CONSTRUCTION BID ADDENDUM NO. 1

TO: **ALL BIDDERS**		DATE ISSUED 10/19/2026
PROJECT NAME Site Utility Underground - Woodland Correctional Center		FILE NUMBER 472/23129.KMM
PROFESSIONAL Nowak & Fraus Engineers	PROJECT DIRECTOR Kurt Maiberger	BID OPENING DATE: 11/18/2026

OVERALL IMPROVEMENT PLAN

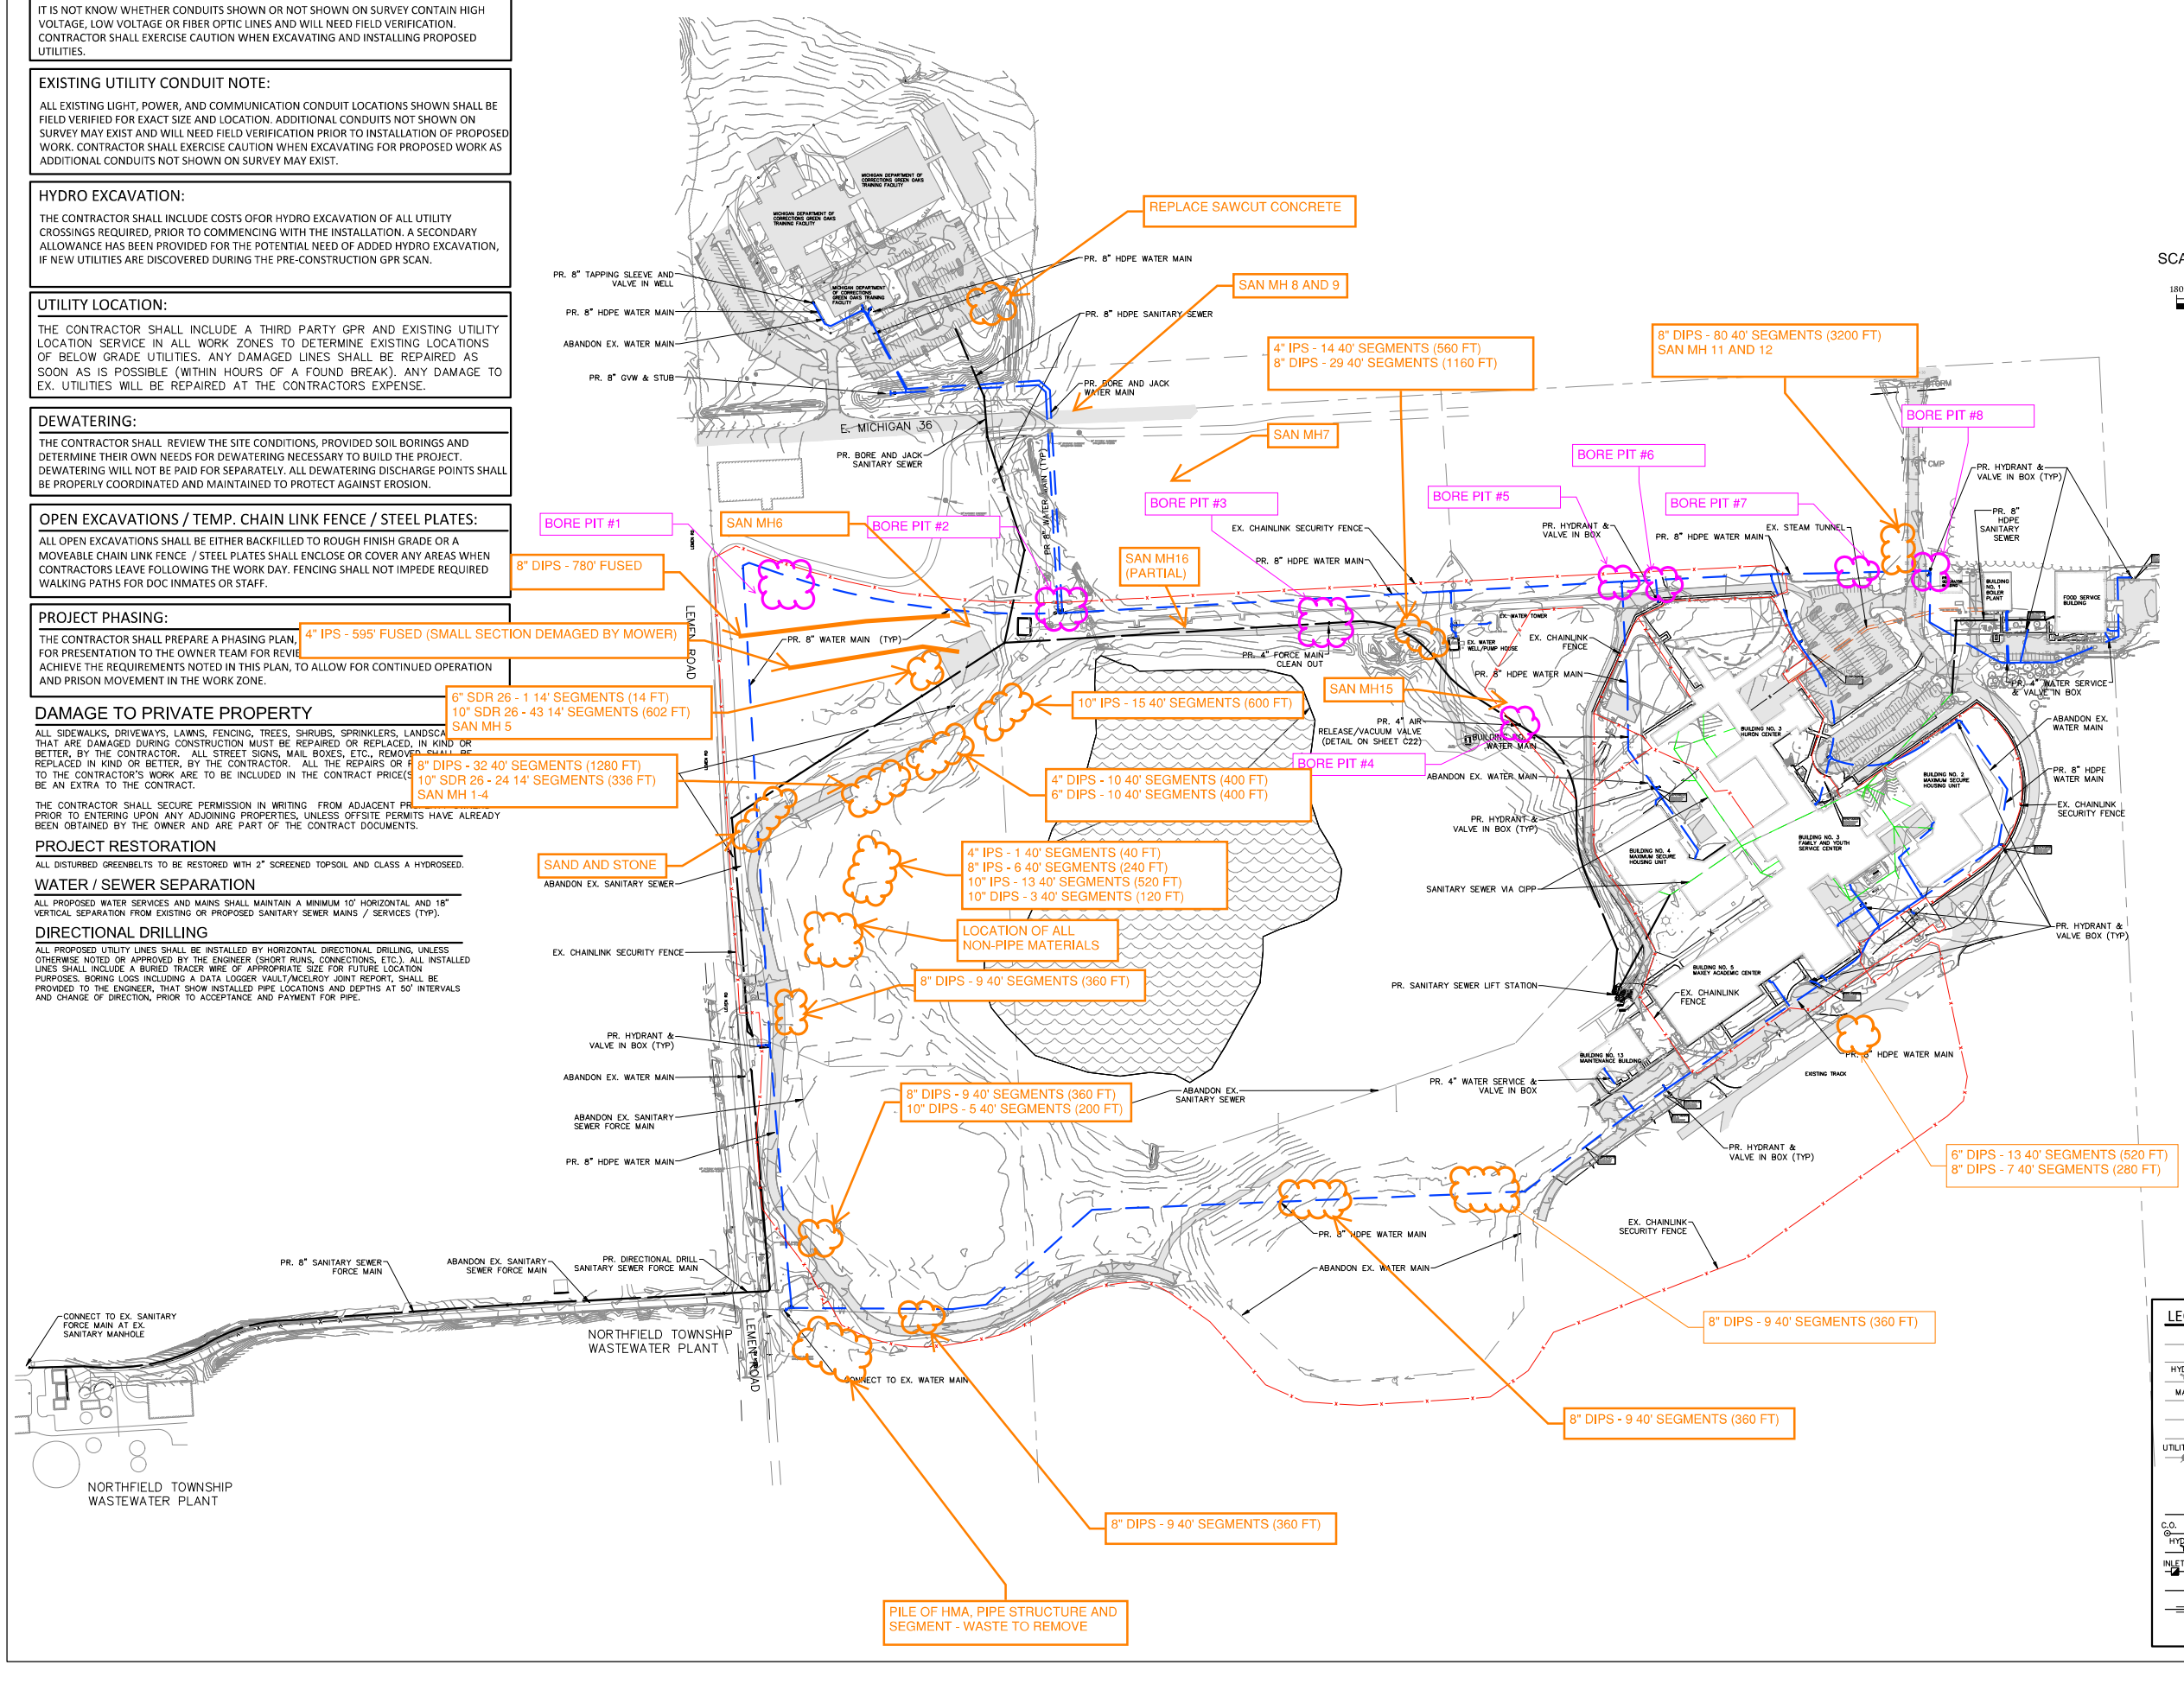
Updated – Modified note referencing "RESTORATION ASSOCIATED WITH PREVIOUS PHASE" on sheets C3 to C17

THERE ARE AREAS THROUGHOUT THE SITE THAT HAD BEEN DISTURBED DURING THE PREVIOUS CONSTRUCTION PHASE WITHIN 150' OF CENTERLINE OF PROPOSED UTILITY IMPROVEMENT AND EXISTING MATERIAL LAY–DOWN AREAS. THE CONTRACTOR WILL BE RESPONSIBLE FOR CLEANING UP DEBRIS, MATERIALS AND OTHER ITEMS LEFT BEHIND DURING THE PREVIOUS PHASE. THE CONTRACTOR WILL BE RESPONSIBLE FOR REPAIRING/RESTORING ANY/ALL AREAS THAT WERE A RESULT OF THAT WORK WITH NECESSARY BACKFILL MATERIAL, GRADING, TOPSOIL AND SEED AND MULCH TO ESTABLISH POSITIVE DRAINAGE AND BLEND WITH EXISTING GROUND.

ALL DISTURBED GREENBELTS TO BE RESTORED WITH 2" SCREENED TOPSOIL AND CLASS A HYDROSEED.
